Access Compliance Report

Public Rights-of-Way

(Curb Ramps)

Intersection ID: 28418	Main Street: AMBRIDGE_DR	Cross Street: CHASTAIN_WALK_DR	Location: NW
ADA ID: 09B6DCFEC702	Ramp Type: Perp	Initial Pass/Fail: Fail	Overall Compliance: No
		Severity Score: 25

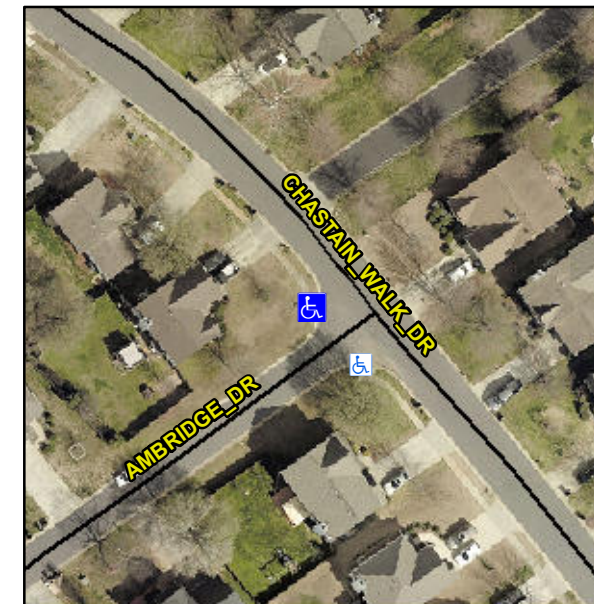
Not Found, R304.2.2, R304.5.3

Compliance	Description	Data	Compliance	Description	Data
N/A	Ramp Length (in)	46.5	No	Ramp Slope (%)	8.7
Yes	Ramp Width (in)	56.0	No	Ramp XSlope (%)	6.2
N/A	Flare Type LT	N/A	N/A	Flare Type RT	N/A
N/A	Flare Slope LT (%)	N/A	N/A	Flare Slope RT (%)	N/A
N/A	Flare Traversable LT?	N/A	N/A	Flare Traversable RT?	N/A
N/A	Landing Length (in)	N/A	N/A	DWS Provided?	N/A
N/A	Landing Width (in)	N/A	N/A	DWS Contrast?	N/A
N/A	Landing Slope (%)	N/A	N/A	DWS Length (in)	N/A
N/A	Landing X Slope (%)	N/A	N/A	DWS Full Width?	N/A
N/A	Landing Curb? (Y/N)	N/A	N/A	DWS Offset (in)	N/A
N/A	Shared Landing?	N/A			
N/A	Gutter Ponding?	N/A	N/A	Gutter Slope (%)	N/A
N/A	Gutter Lip Ht (in)	N/A	N/A	Gutter X Slope (%)	N/A
N/A	Painted X Walk1?	No	N/A	Painted X Walk2?	N/A
	X Walk 1 Direction	To SW		X Walk 2 Direction	N/A
N/A	X Walk 1 Width (in)	N/A	N/A	X Walk 2 Width (in)	N/A
	X Walk 1 Slope (%)	1.6		X Walk 2 Slope (%)	N/A
	X Walk 1 X Slope (%)	2.8		X Walk 2 X Slope (%)	N/A

Remove & Replace Entire Ramp.
